POTENTIAL FINDING REPORT
SONGS 2&3 SEISMIC DESIGN VERIFICATION

PFR NO. 2408-PFR-F003

AFFECTED ITEMS: 408 volt Motor Control Centers (MCC). Seismic Category I (BPC Spec. S023-302-4 + B Addendum)

FIGURE 1

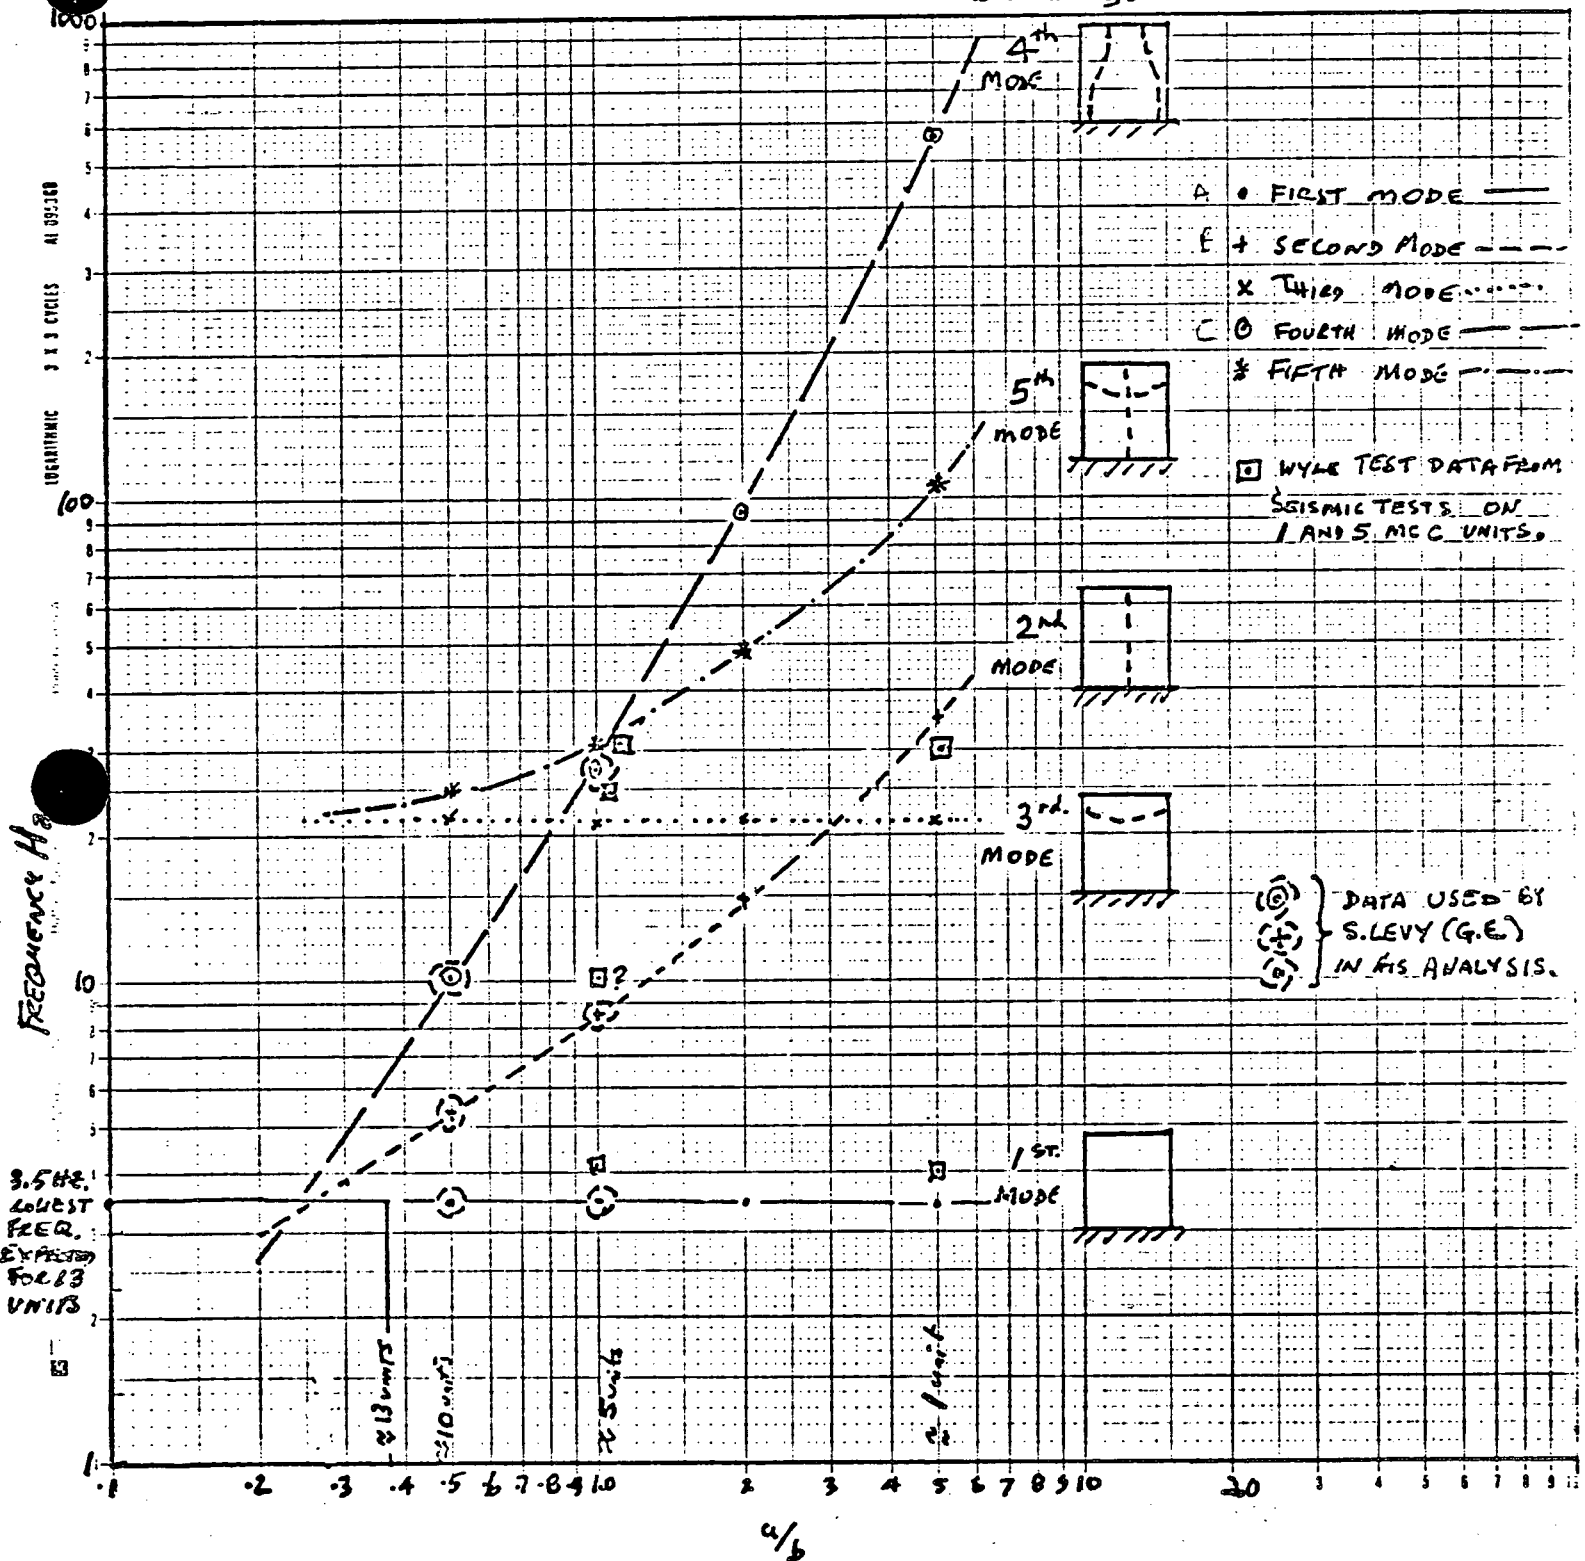
Bechtel's response to Item 1 on PFR-F003 from seismic test data on one and five unit MCC array, is that five units are stiffer with less response amplification than a single unit. Bechtel infers from the data that testing 1 or 5 units is conservative qualification for 6 or more units. This concept is backed up by two analytical reports by S. Levy of G.E., (8/1/81 and 5/3/79). Levy uses information documented in Harris and Crede (Shock and Vibration Handbook, Vol. 1, page 7-31, Table 7.8) on natural frequencies of cantilevered rectangular plates. Unfortunately, Mr. Levy uses only a portion of the data (i.e. equivalent to 5 and 10 unit array and Modes 1, 2 and 4 - see Fig. 1). From this limited set of data points, Levy deduces that for plates the natural frequencies for Modes 2 and 4 for given length to height ratio is always higher than the natural frequency for Mode 1. Levy then states that it is reasonable to assume a similar relationship for the lineup of motor control centers. Unfortunately Mr. Levy did not evaluate what happens when the data is extrapolated to height to length ratios equivalent to 13 or more MCC units. The total data from Table 7.8 for all five mode shapes is plotted in Figure 1. It is evident that for very long rectangular plates that the natural frequencies for Modes 2 and 4 can fall below the natural frequency for Mode 1. Thus Mr. Levy's and Bechtel's premise that the longer the array the higher the natural frequency is invalid.

Fortunately, for the present seismic review the largest MCC array is 13 units. For a unit height of approximately 100 inches (7'6" + a 12 inch pull box) and width of 20", this is a height to width ratio of .38. At this point the natural frequencies of Modes 2 and 4 are still above Mode 1.

The natural frequencies for 1 unit and 5 units from Wyle's test data are also plotted on Fig. 1. This shows good correlation for Mode 1 and reasonable correlation in determining the other resonance peaks. Wyle uses a minimum transmissibility factor of 2 as a cut off in determining resonance peaks. Evaluation of some of the smaller resonance peaks would probably identify other modes. If for conservatism, we use the data for the plate, rather than actual tests of the MCC units, then our lowest natural frequency for a 13 unit array is 3.5 HZ (Fig. 1, Height to Length Ratio = .38). For further conservatism, and to allow for uncertainties in the curves, we reduce this value by a further 10% (i.e. to 3.2 HZ or a period of 0.31 seconds).

DESIGN BASIS EARTHQUAKE
 HORIZONTAL ACCELERATION RESPONSE
 SPECTRA AT NODE 9, ELEVATION 50'-0"
 OF AUXILIARY BUILDING

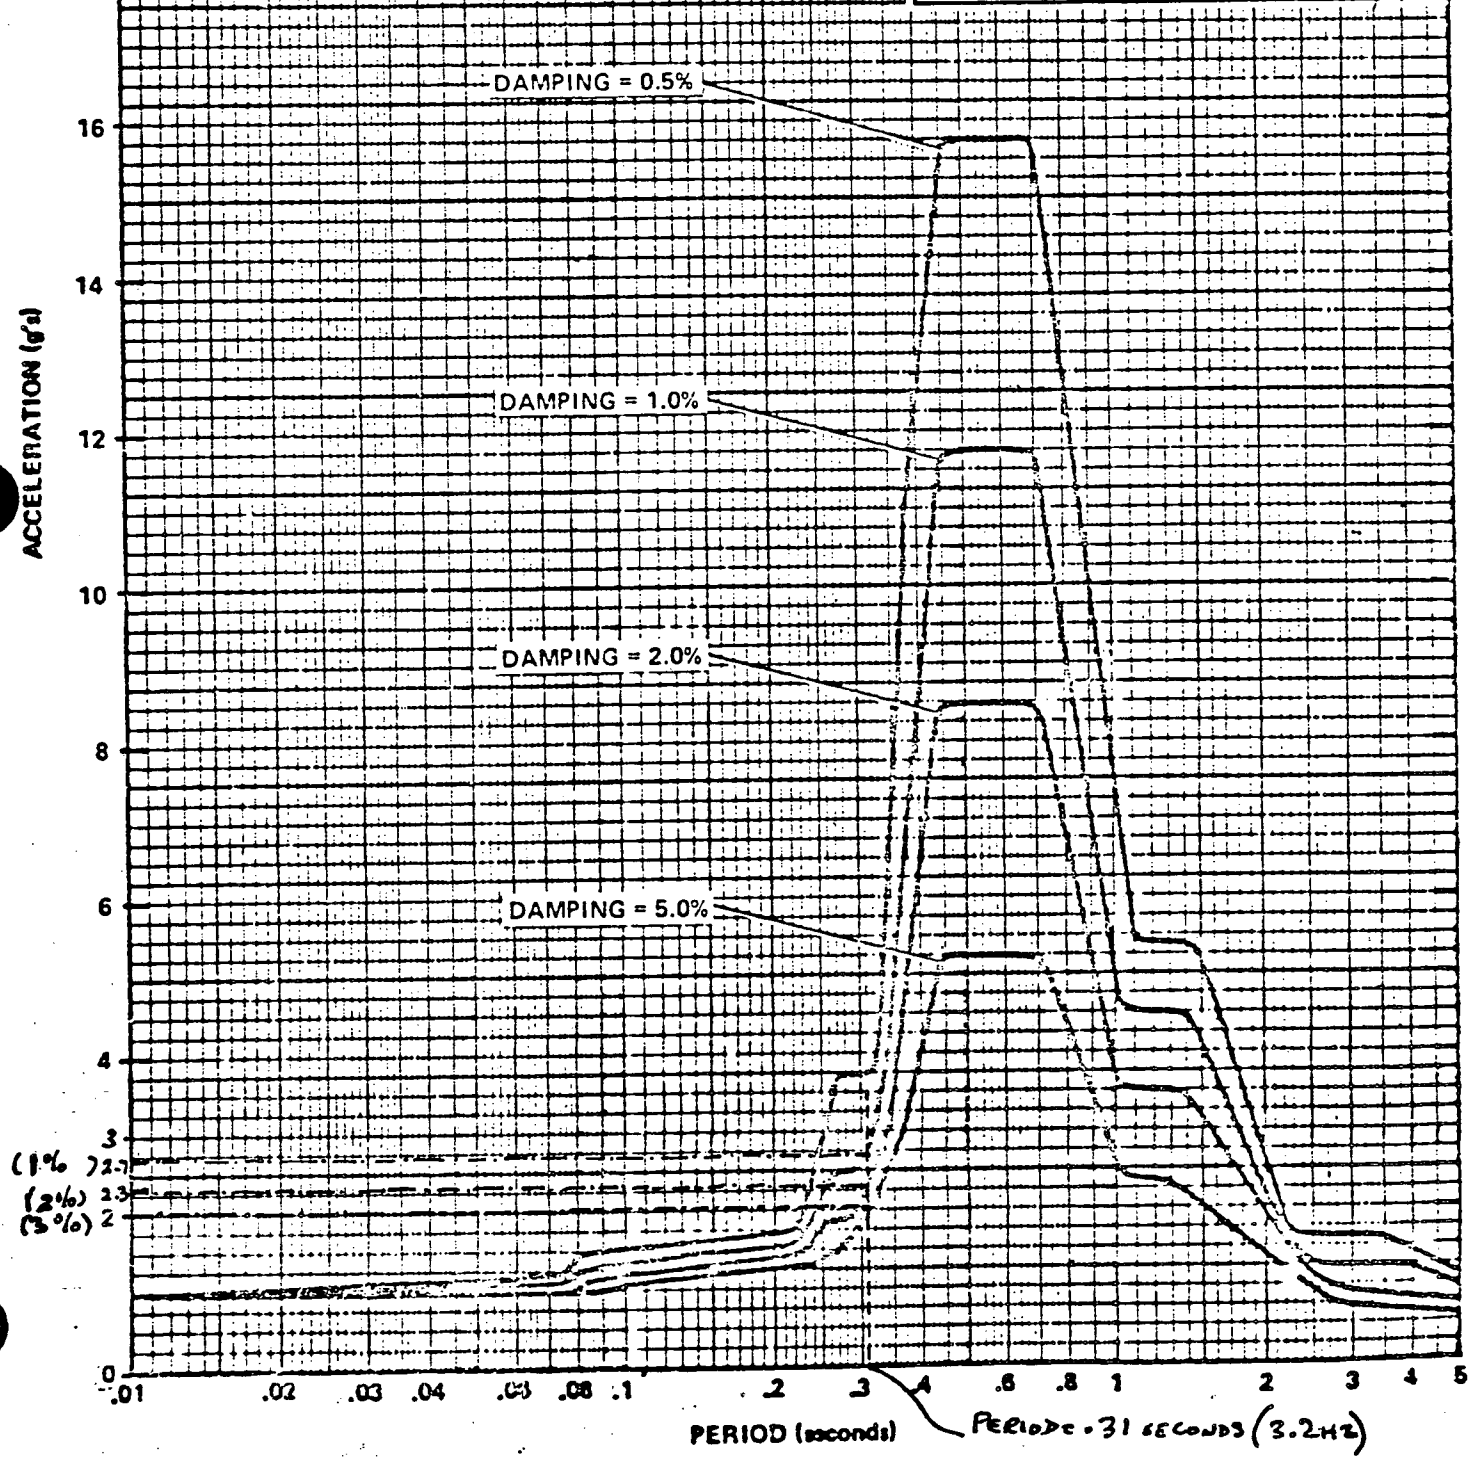
If we look at the DBE horizontal acceleration response spectra at damping values of 1%, 2% and 5% and a period of .31 seconds, we get acceleration levels of 2.7 g's; 2.3 g's and 2.0 g's respectively (Fig. 2). Wyle tested the units to 3 g's or better over the frequency range of concern (i.e. ~ 2.5 to 250 HZ).

2408-KFIC-0074
NUMBER 25-201 1A-221
SHEET 4 OF 30
DATE 7-20-76 BY W. J. J. J.
CHECK DATE 8-11-76 BY W. J. J. J.

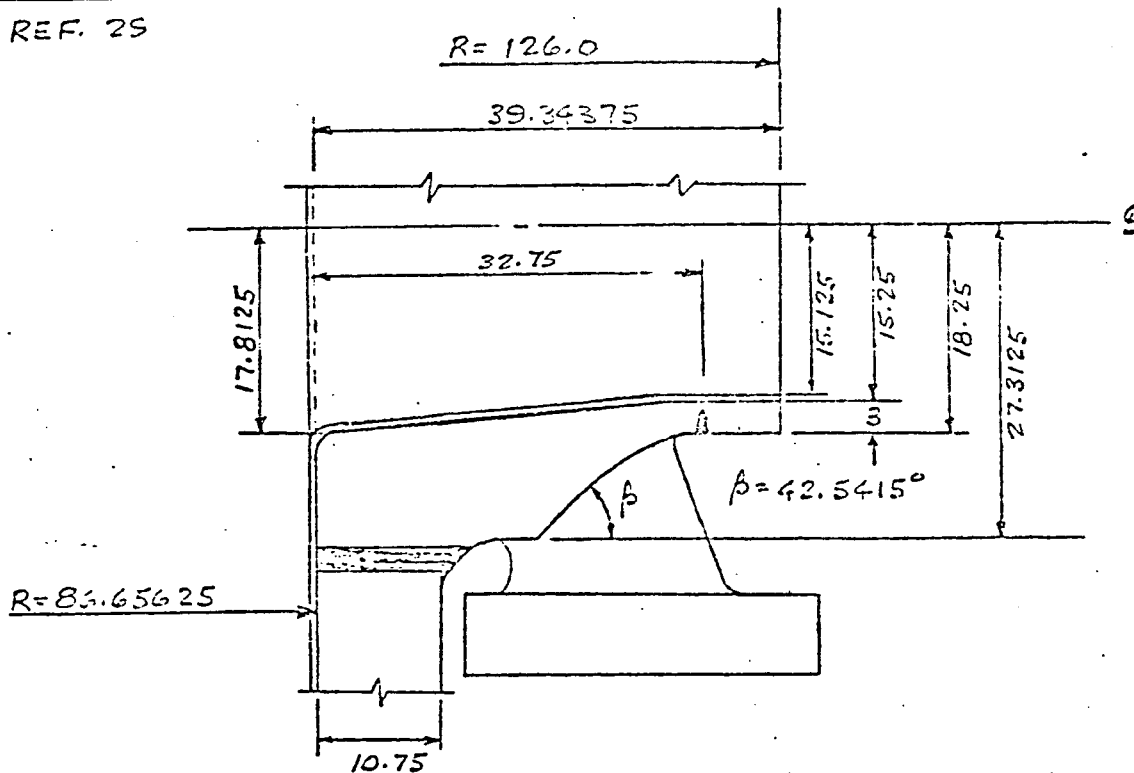
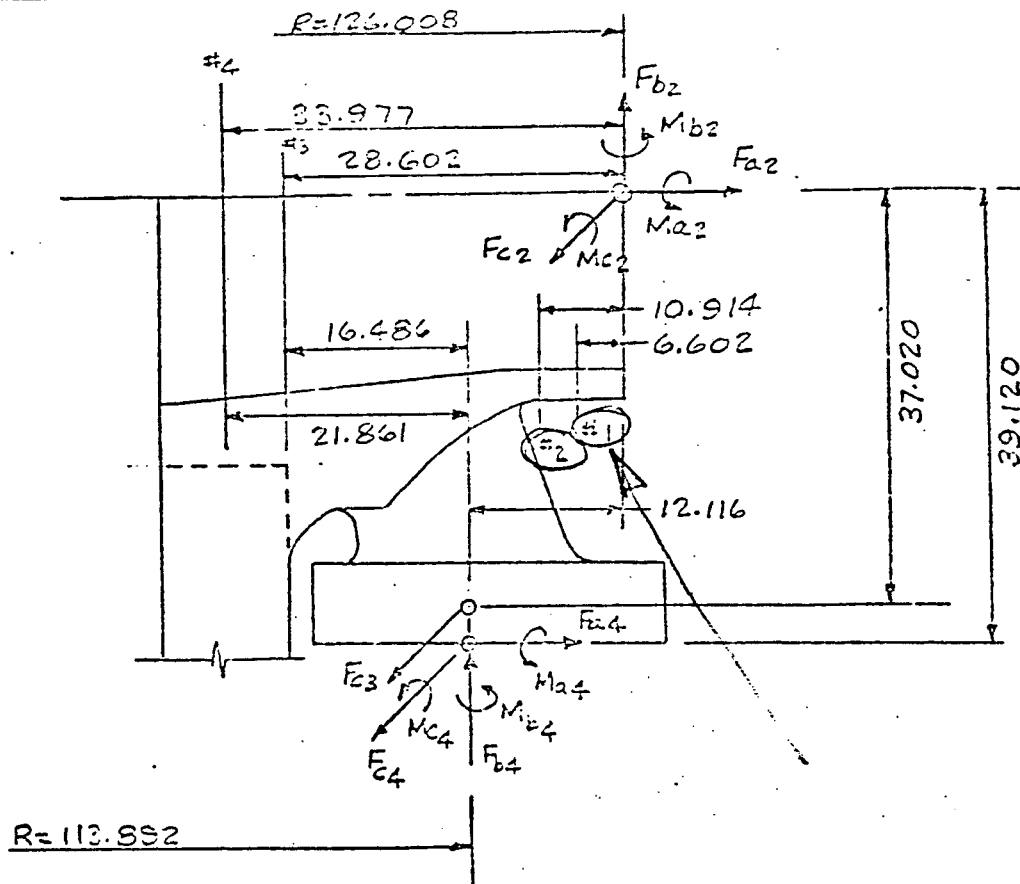
On sheet 4 of 30 (RS-201 of Ref. 1) the geometry and the corresponding material properties are presented for the nozzle. Three different materials are listed. On sheet 17 of 30 (RS-201 of Ref. 1) the locations for specific points of analysis are given. Cut No. 1 is of particular interest because it lies in the material that has the lowest stress allowables of the three material types mentioned above. Now when the maximum stresses for normal operating conditions were checked with the allowables (Sh 23 of 30), the appropriate material was used for Cut No. 1. But when the check was made for the faulted conditions at Cut No. 1 (Sht 21 of 35, RS-205 of Ref 1), a comparison of stresses was made using the wrong material stress allowables. This is also the case on sheet 23 of 35 (RS-205 of Ref. 1). A larger stress allowable was used instead of the appropriate allowable for Cut No. 1.

Reply: The values for S_m on pages 21 and 23 of RS-205 were checked and were found to be in error. The correct value used is $S_m = .7S_u = .7(70) = 49$ ksi. The value used is $S_m = .7S_u = .7(80) = 56$ ksi. This error will be corrected.

All ASME Code stress intensity allowables for faulted primary stresses have been met after comparison to the appropriate revised S_m allowable of 49.0 ksi as noted below.
